FINAL
ENVIRONMENTAL IMPACT STATEMENT

F-15E BEDDOWN AT SEYMOUR JOHNSON AFB,
NORTH CAROLINA

November 18, 1988

TABLE 3.2-2
A-WEIGHTED PEAK NOISE LEVEL [dB(A)]

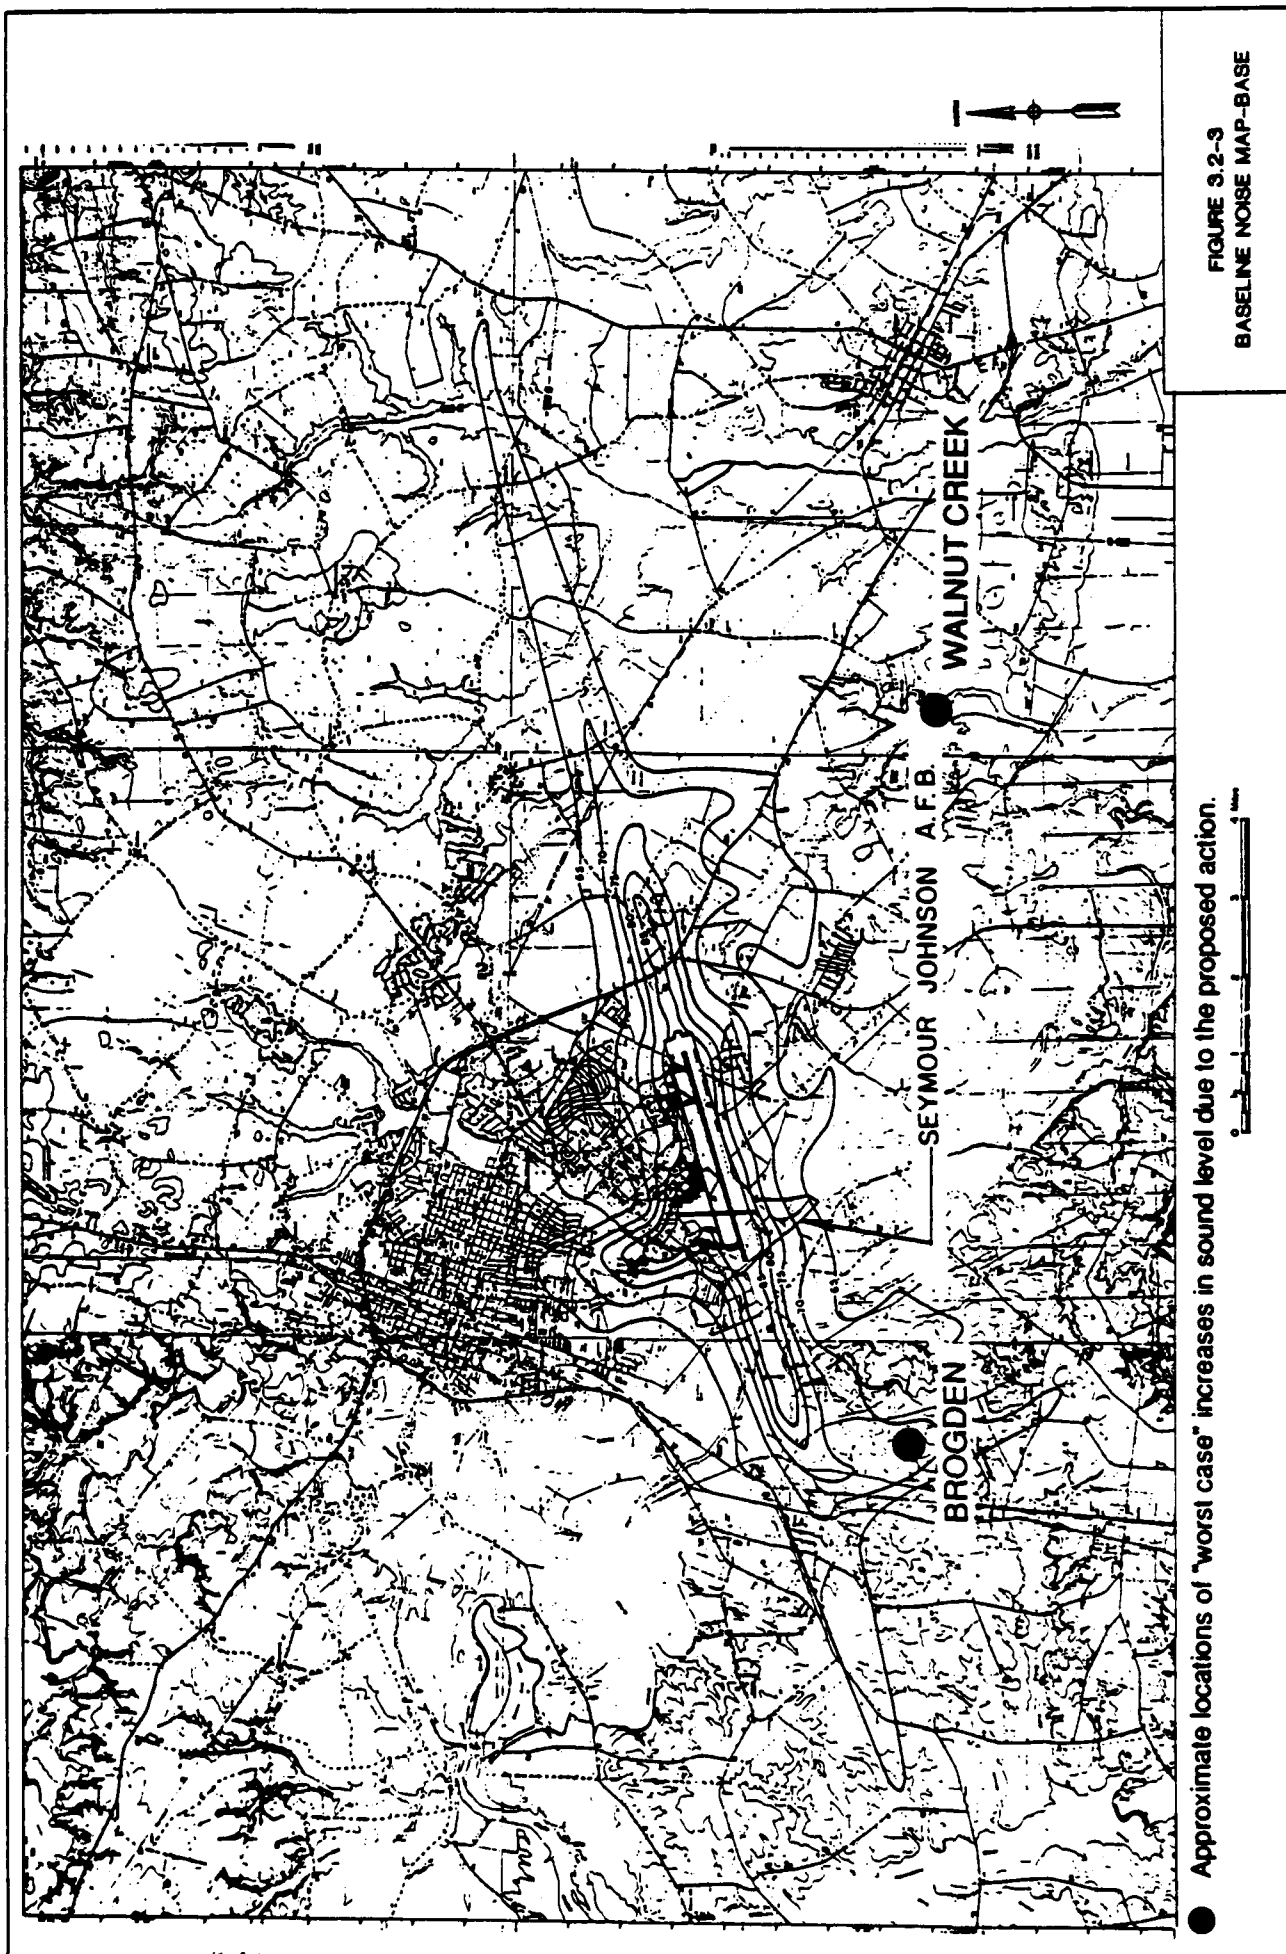
71 | Page 3.2-14. The information presented in Table 3.2-2 is much to limited to provide the breadth of data needed to understand the full range of operational conditions. As discussed on page 3.2-7, ground level noise exposure is determined by aircraft power setting, altitude, and duration of exposure. Therefore, the table should include the following information in addition to

71 that already shown. The observer to aircraft distance column should include a 50 foot measures since this is the lowest anticipated flight and closest exposure. There should also be groupings of noise level data arranged by power setting (minimum approach, cruise, afterburner). This will provide the draft EIS with sufficient data to allow understanding and analysis of the proposal.

15. p. 3.2-5, Figure 3.2-3: See revised Figure in this section.
16. p. 3.2-14, Table 3.2-2: See revised Table in this section.
17. p. 3.3-7, 1st paragraph of section 3.3.5: Delete "or around." Add following sentence: Cliffs of the Neuse State Park does provide some unique geological features.

TABLE 4.2-2
COMPARISON OF NOISE LEVELS FOR SEYMOUR JOHNSON MTRs¹

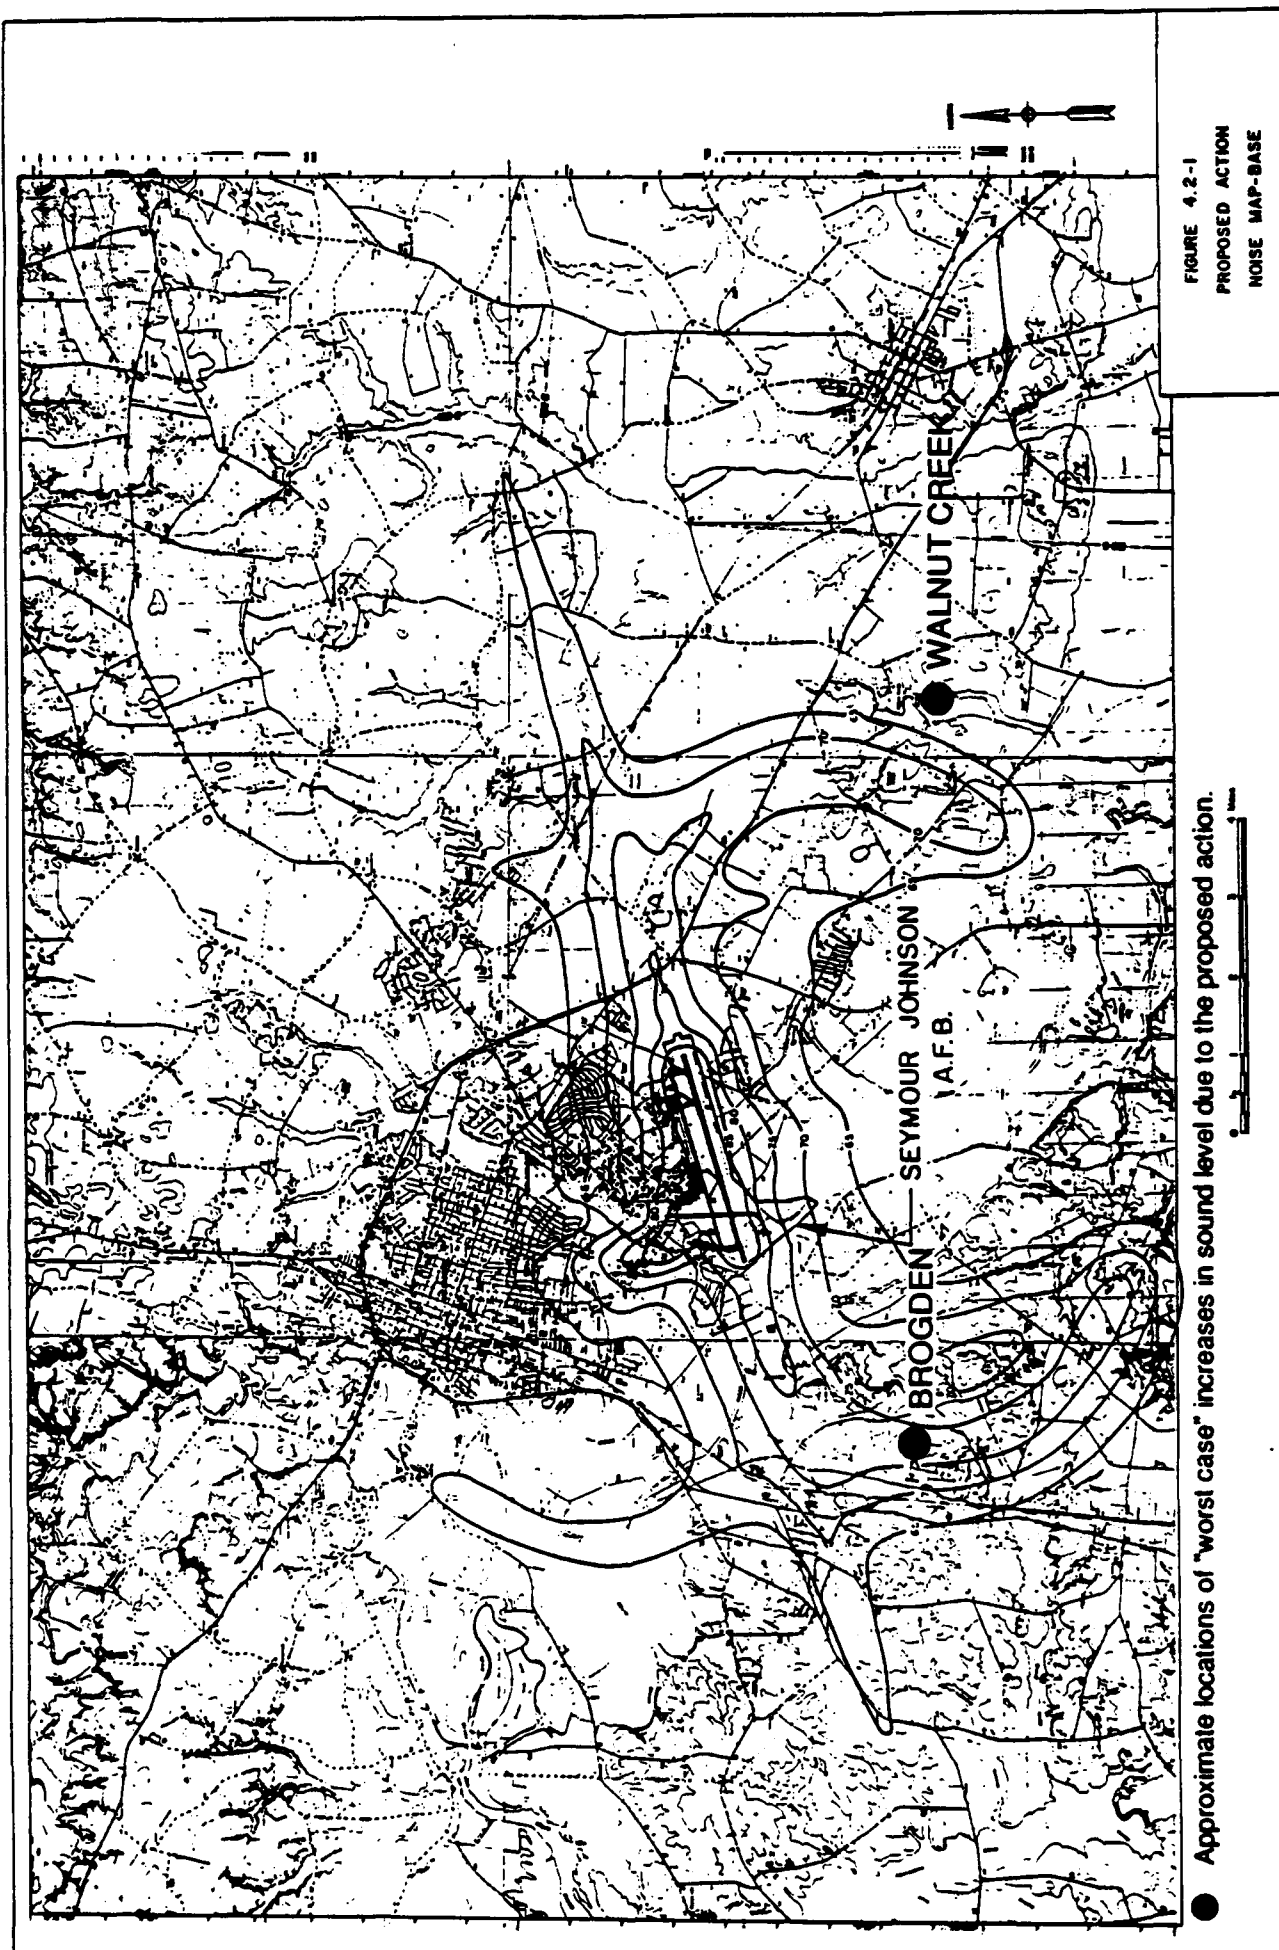
- 6 ° Table 4.7-3 notes that the "worst case" impact represents a potential increase of 20 dB in DNL for about 537 dwelling units. This involves an exposed population of 1603 people "outside AICUZ." These homes were identified as being in the Brogden and Walnut Creek geographic areas. The significance of the "worst case" 20 dB increase would be easier to determine if the table gave the ambient noise level to which the 20 dB increase would be added. With this information a practical "worst case" evaluation could be made.

23. p. 4.2-5, Table 4.2-2. See revised Table in this section.
24. p. 4.2-8, paragraph 5, line 3: Delete the word "slight".

Figure B-1 VR-073

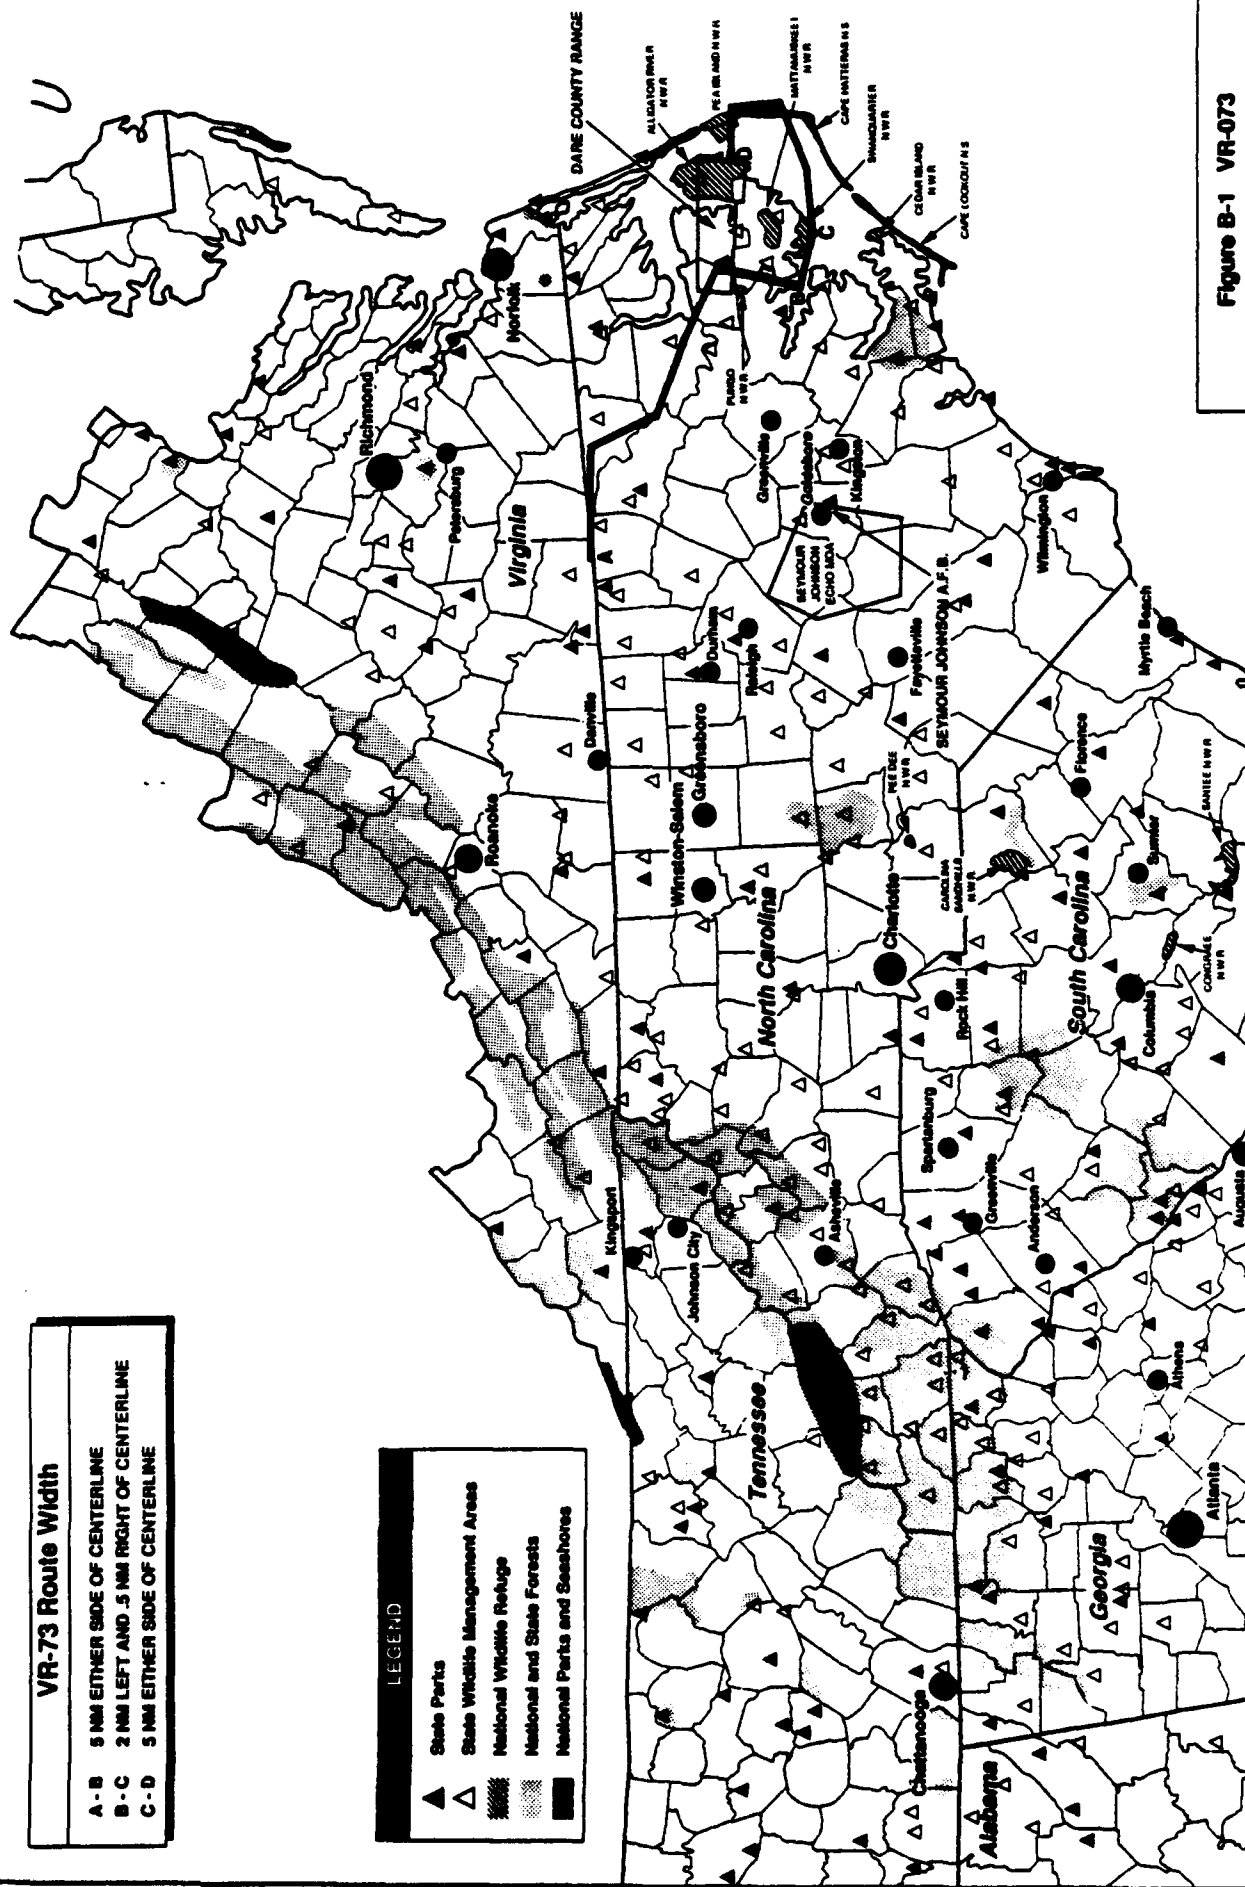
30 | Three refuges, including Pee Dee NWR, Carolina Sandhills NWR and Pea Island NWR, appear from Figure 3.0-2 to be traversed by MTR's. The minimum altitude on Route VR73, which crosses Pea Island NWR, is 100 feet AGL. Pea Island NWR is the southernmost nesting area for black ducks and gadwalls and is a major wintering area in North Carolina for the greater snow goose. The major fall migration route of the threatened Arctic peregrine falcon follows the Outer Banks through the refuge. The major resource management objectives at Pea Island NWR includes provision of wintering habitat for the greater snow goose and other migratory waterfowl, habitat and protection for threatened and endangered species, and habitat for migratory birds on the Atlantic Flyway.

Another area of concern regarding MTR's involves selection based upon low human population density. In general areas with low human activity provide the highest quality remaining wildlife habitat. Examples include VR1752 and VR73 which follow all or portions of the Roanoke River Basin. Bottomland and swamp forests along the Roanoke River provide some of the highest quality habitat remaining for numerous game and nongame species in the entire State. Because of the quality of habitat underneath these MTR's for wildlife resources, utilization by outdoor recreationists, potential impacts from a 34% increase in flight activities (primarily at night), and ownership by the Wildlife Resources Commission of nearly 14,000 acres we strongly encourage treatment of these MTR's as environmentally sensitive areas and believe they should receive special attention. There other publicly owned areas by State or Federal agencies which should receive additional attention regarding environmental impacts.

77. The correct reference is to Figure 3.0-2. See errata (Chapter 5). Additional information on the location of "wildlife management and recreation areas" is provided in Appendix B.

Figure B-9 VR-1043

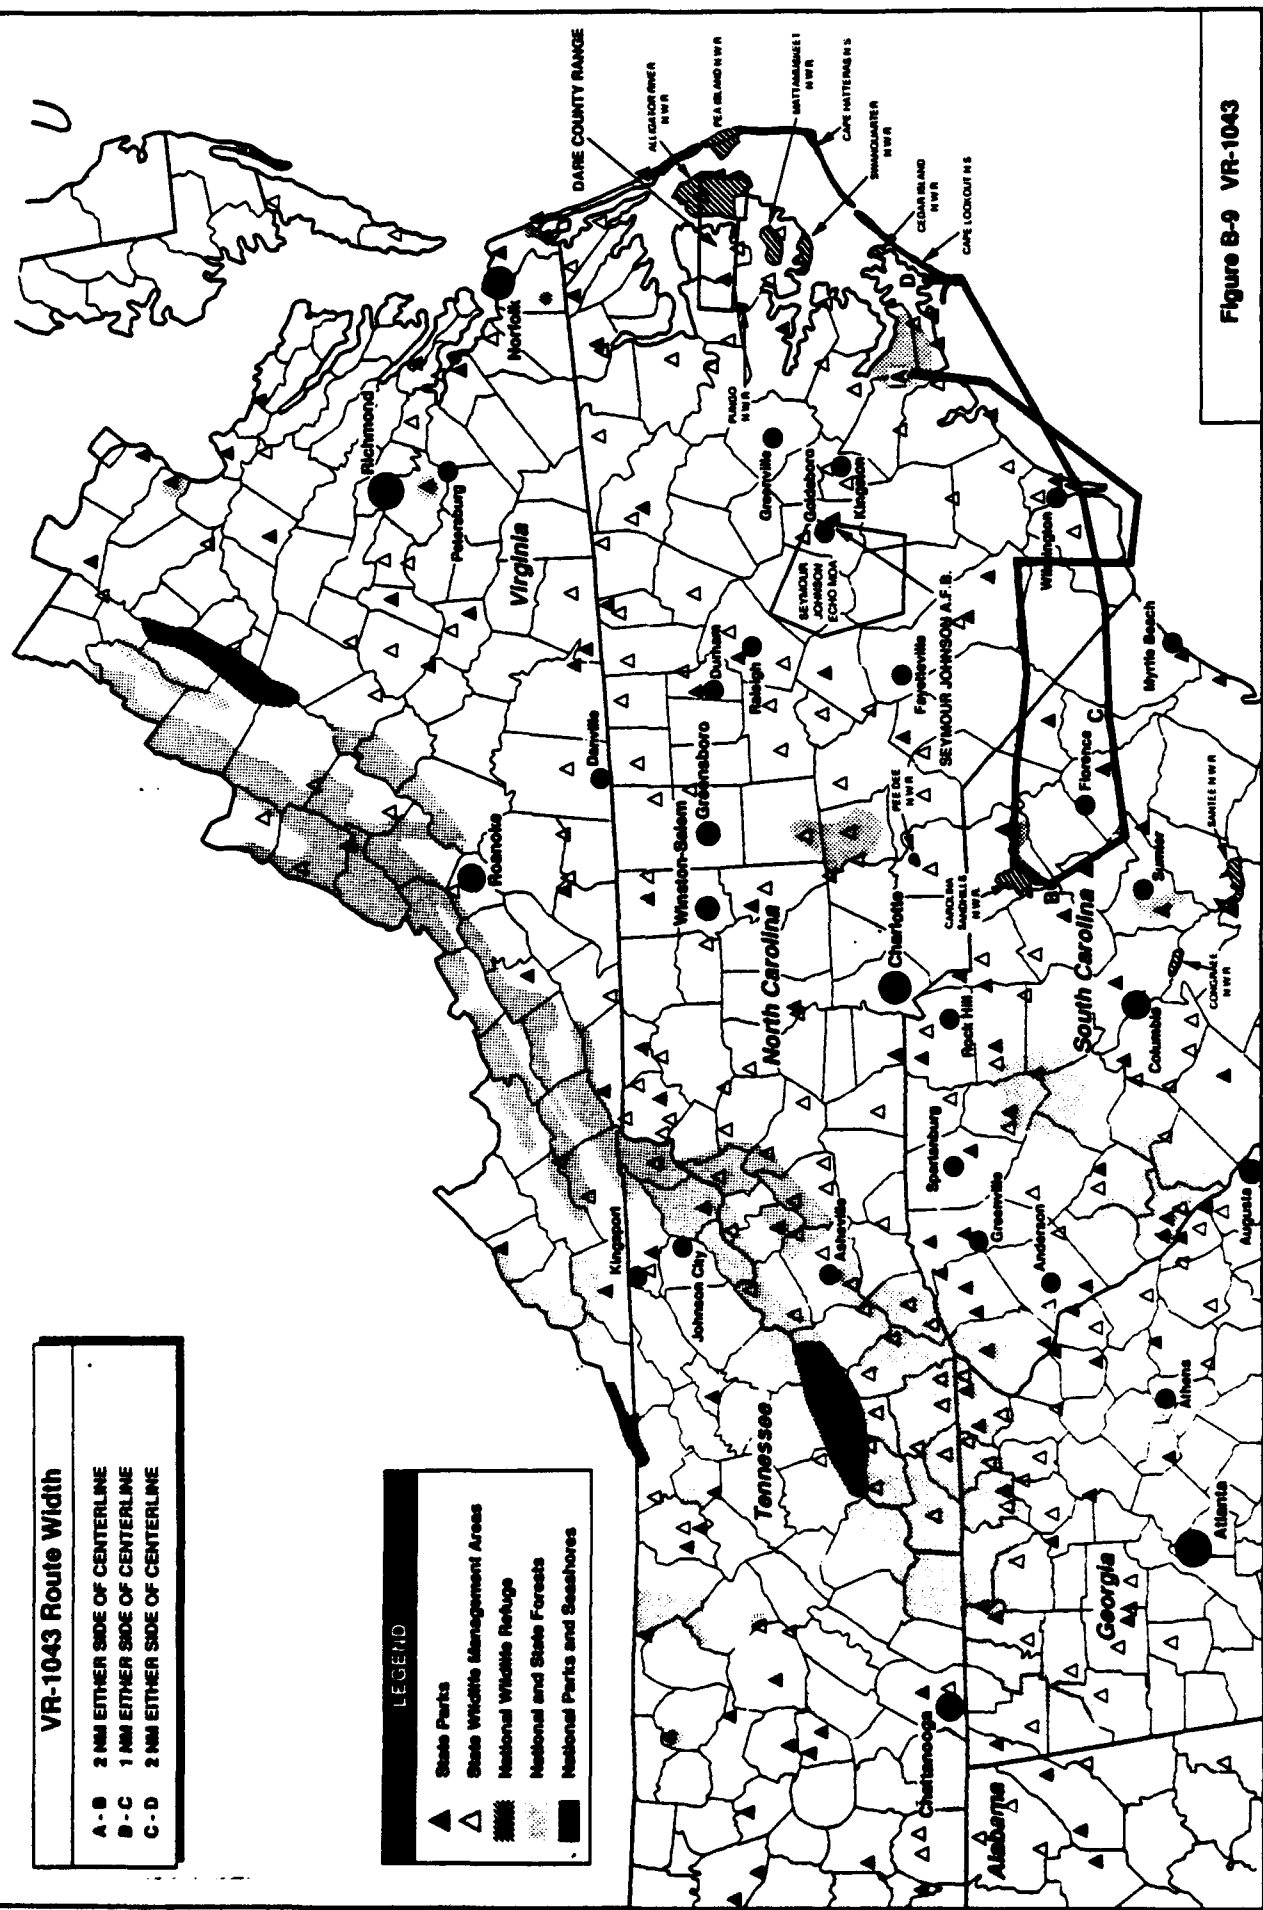
100 | aircraft. The proposed increase in use of VR-1043 will exacerbate this problem. MTRs VR-1046 and VR-1074 will affect Goose Creek State Park in Beaufort County. Other state parks may be impacted by increased use of MTRs, but DEIS Figure 3.0-2 is insufficient to compare the location of the MTRs with the locations of the parks.

13. p. 2.4-2, Table 2.4-1, Impact Area, No Action Alternative, and Proposed Action columns: Insert "Fire Potential", 0, and 0, respectively.
14. p. 3.0-3, Figure 3.0-2, VR-096 and VR-1043. Routes were drawn beyond legs specified in AP1B extracts for MTRs. See revised maps in Appendix B.
